Subject: 648 Module Acrylic Modification

Number: SRV0029

Applicability: SolarForce 648

Date: 10/24/2007

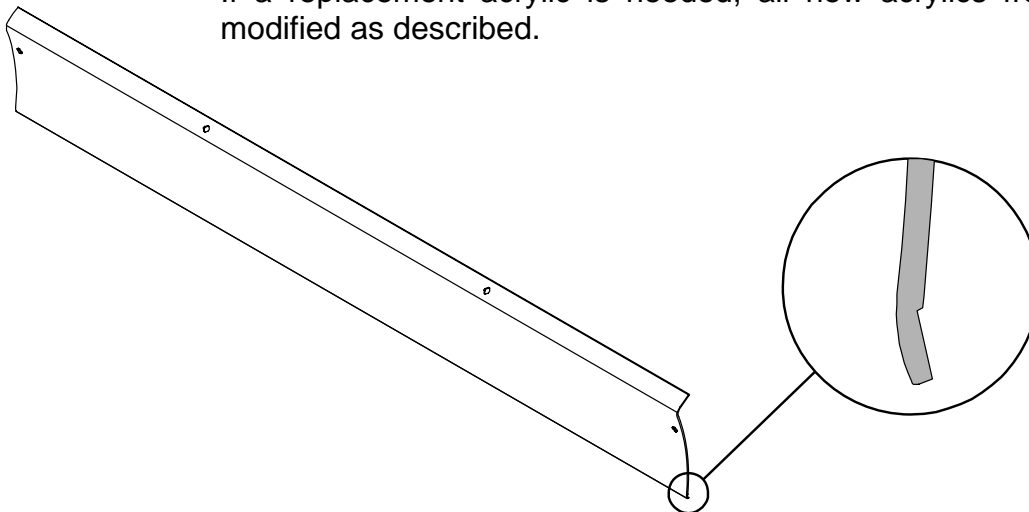
Symptoms: The rear module acrylic on the 648 becomes difficult to remove and reinstall.

Explanation: Over time, after many heat and cool cycles, acrylics will naturally reform slightly (warp). This reforming causes the rear module acrylic to bind in the metal channel.

Solution: ETS has modified the rear module acrylic to allow for this natural reformation. The lower edge of the acrylic has been shaved slightly (see below). New acrylics will fit looser in the metal channel, but the quarter-turn locks will hold it in place securely so the customer will not notice.

Older acrylics should still work fine with these simple techniques:

If the acrylic is difficult to remove, press or bump carefully with the heel of your hand on the center of the acrylic as you lift.

Reinstalling the acrylic should not be a problem, although it may fit snugly.

If a replacement acrylic is needed, all new acrylics from ETS will be modified as described.
